Waterloo Estate (South) Planning Proposal – Submission

In February 2020 the Council and the Central Sydney Planning Committee (CSPS) approved a planning proposal and draft design guide for the Waterloo Estate (South). The proposal was informed by the City's Alternative Approach to Waterloo, that was in turn reviewed and guided by an Expert Advisory Panel that included:

Figure 2: City's proposed height in metres map (LEP)

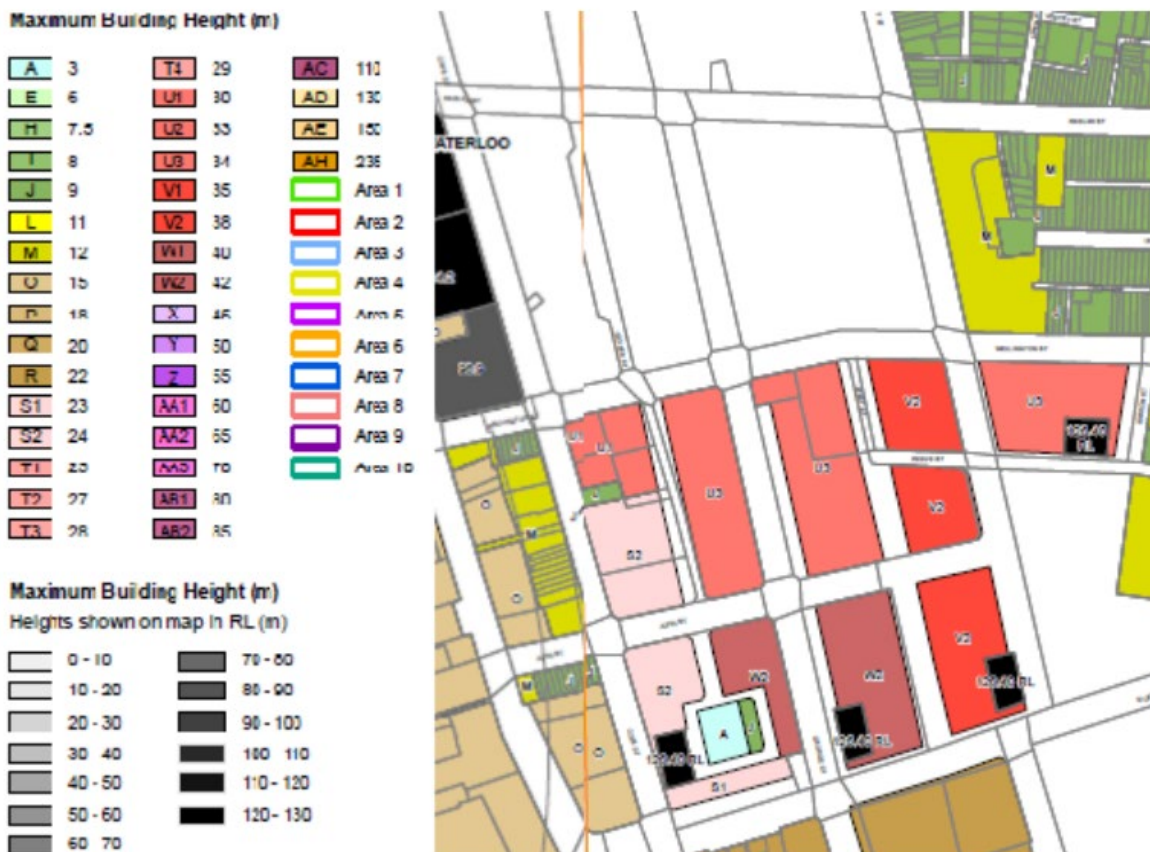
The maximum building heights in the planning proposal (LEP maps) (Figure 2) have significantly changed from what was proposed by the City (Figure 3). The change is prompted by the Gateway determination instruction to modify the height map to “*remove the 3m and/or 6m height control that depicts the location of private internal courtyards and apply the adjacent maximum heights*” and to “*set simplified maximum heights above ground on the Height of Building Map, including an allowance for roof top communal facilities and flood levels*”.

The simplification of the LEP maps allows for a significantly altered building envelope than that shown in the draft design guide and places several of the aims and principles of the planning proposal in jeopardy. Key risks include:

- placing heights on lots containing heritage items well beyond the existing height of the item;
- increased height immediately adjacent to heritage items;
- exposing narrower streets to heights that are in proportion to wider streets or park frontages on the opposite side of the blocks;
- loss of articulation of height in relation to street width and orientation, park frontage, and corner emphasis;
- substantial decreases of sun access to streets and parks;
- loss of relationship to areas subject to flooding; and
- loss of relationship to the topography.

- Reconsider and adopt where relevant the reduced building heights along streets shown in the preferred direction of the Addendum Urban Design Review.
- Rework the maximum building height map in the planning proposal to have height zones relating to street widths and park locations.
- Reconcile the height in storeys map in the draft design guide, with the maximum height of buildings map in the planning proposal to ensure they are consistent. This is to provide clarity for the community and future landowners and ensure certainty in the development application process.
